SUBJECT: NORTH ANNA UNITS 1 AND 2 - ISSUANCE OF AMENDMENTS RE:
PRESSURE/TEMPERATURE OPERATING LIMITS AND LOW
TEMPERATURE/OVERPRESSURE PROTECTION SYSTEM SETPOINTS
(TAC NOS. M83154 AND M83155)

The amendments revise the pressure/temperature (P/T) operating limitations during heatup and cooldown and the low temperature/overpressure protection systems (LTOPS) setpoints for 12 and 17 effective full power years for NA-1&2, respectively.

AMENDMENT NO. 170 TO FACILITY OPERATING LICENSE NO. NPF-4-NORTH ANNA UNIT 1
AMENDMENT NO. 149 TO FACILITY OPERATING LICENSE NO. NPF-7-NORTH ANNA UNIT 2

Figure 3.4-2 Unit 1 RCS HEATUP P/T Limits
 Valid to 12 EFY Heatup Rates: 0-60°F/Hr.
 (Margins for Instrument Errors NOT Included)

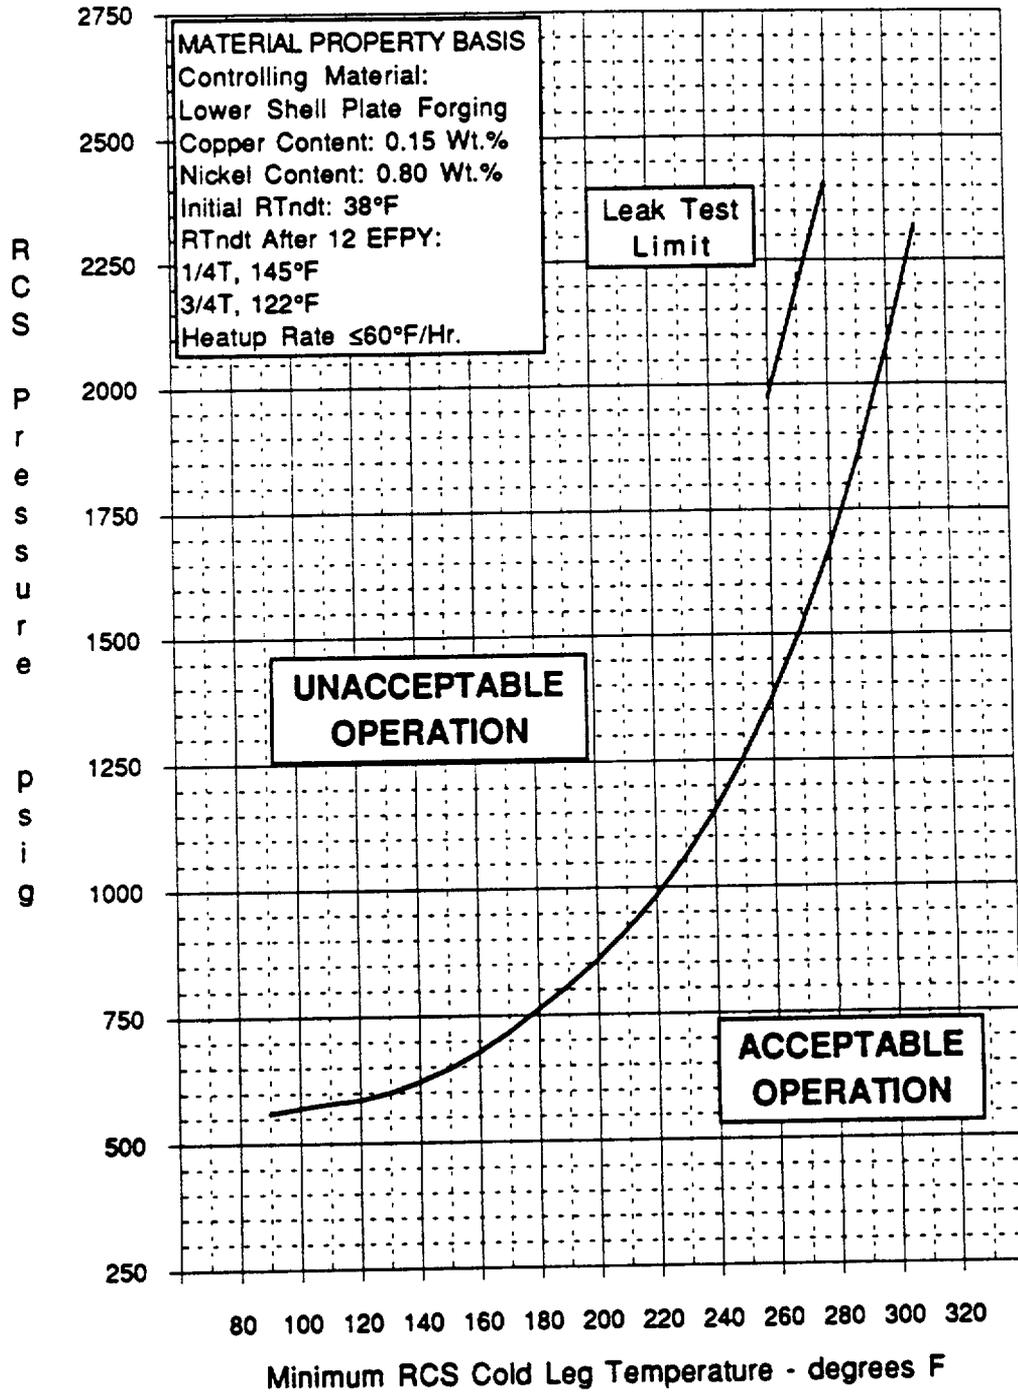
The heatup limit curve, Figure 3.4-2, is a composite curve which was prepared by determining the most conservative case, with either the inside or outside wall controlling for any heatup rate up to 60°F per hour. The cooldown limit curves of Figure 3.4-3 are composite curves which were prepared based upon the same type analysis with the exception that the controlling location is always the inside wall where the cooldown thermal gradients tend to produce tensile stresses while producing compressive stresses at the outside wall. The heatup and cooldown curves are prepared based upon the most limiting value of the predicted adjusted reference temperature at the end of 12 EFPY. The adjusted reference temperature was calculated using results from a capsule removed after the sixth fuel cycle. The results are documented in Westinghouse Report WCAP-11777, February 1988 and Babcock and Wilcox Report BAW-2146, October, 1991.

The pressure-temperature limit lines shown on Figure 3.4-2 for inservice leak and hydrostatic testing have been provided to assure compliance with the minimum temperature requirements of Appendix G to 10 CFR 50. The minimum temperature for criticality specified in T.S. 3.1.1.5 assures compliance with the criticality limits of 10 CFR 50 Appendix G.

Figure 3.4-2 Unit 2 RCS HEATUP P/T Limits
 Valid to 17 EFPY Heatup Rates: 0-60°F/Hr.
 (Margins for Instrument Errors NOT Included)

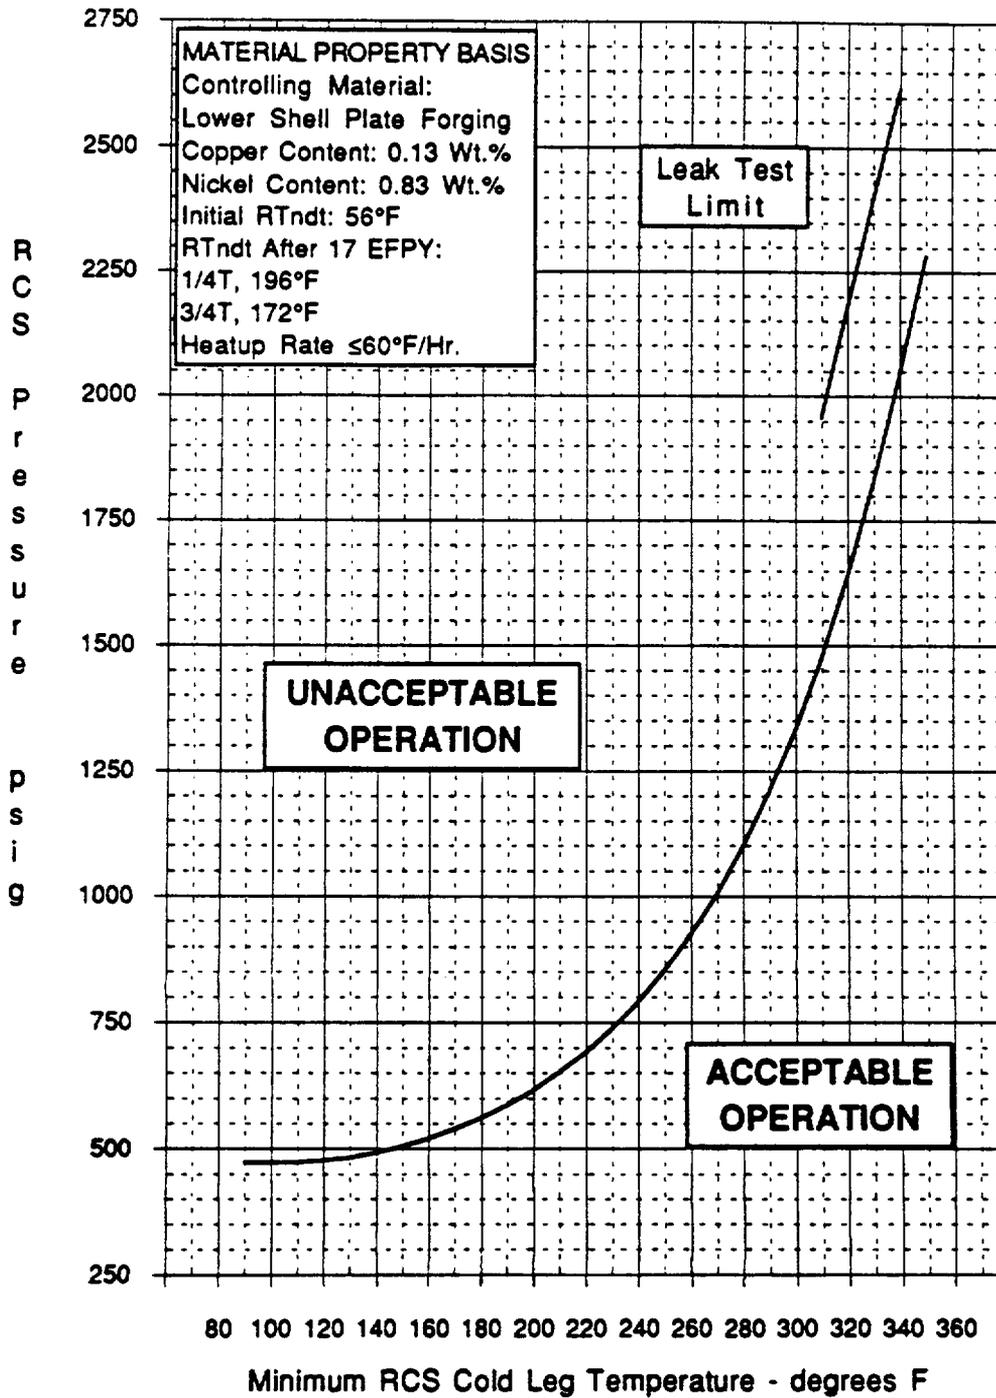
The heatup limit curve, Figure 3.4-2, is a composite curve which was prepared by determining the most conservative case, with either the inside or outside wall controlling for any heatup rate up to 60°F per hour. The cooldown limit curves of Figure 3.4-3 are composite curves which were prepared based upon the same type analysis with the exception that the controlling location is always the inside wall where the cooldown thermal gradients tend to produce tensile stresses while producing compressive stresses at the outside wall. The heatup and cooldown curves are prepared based upon the most limiting value of the predicted adjusted reference temperature at the end of 17 EFPY. The adjusted reference temperature was calculated using results from a capsule removed after the sixth fuel cycle. The results are documented in Westinghouse Report WCAP-12497, January 1990 and WCAP-12503, March, 1990.

The pressure-temperature limit lines shown on Figure 3.4-2 for inservice leak and hydrostatic testing have been provided to assure compliance with the minimum temperature requirements of Appendix G to 10 CFR 50. The minimum temperature for criticality specified in T.S. 3.1.1.5 assures compliance with the criticality limits of 10 CFR 50 Appendix G.
